APPLICATION NO.	FILING DATE	FIRST NAMED INVENTOR	ATTORNEY DOCKET NO.	CONFIRMATION NO.
10/579,583	05/17/2006	Dickory Rudduck	PA063/CL 15199	3574
57346	7590	01/30/2009		
TELEZYGOLOGY, INC.				
520 W. ERIE STREET, SUITE 210				
CHICAGO, IL 60654				
EXAMINER				
LAVINDER, JACK W				
ART UNIT		PAPER NUMBER		
3677				
MAIL DATE		DELIVERY MODE		
01/30/2009		PAPER

### Office Action Summary

## DETAILED ACTION

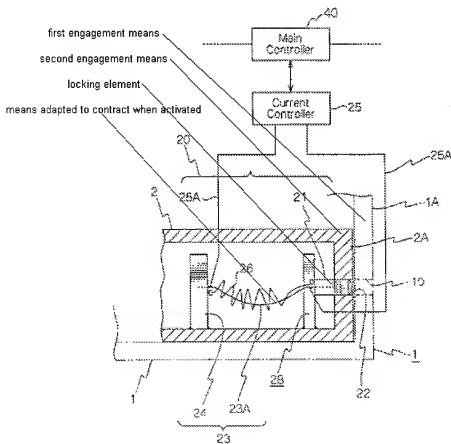
Claims 47 and 50 has been rejected under 35 U.S.C. 102(b) as being anticipated by Kawakami, 6008992.

Kawakami discloses the invention as shown in the annotated drawing.
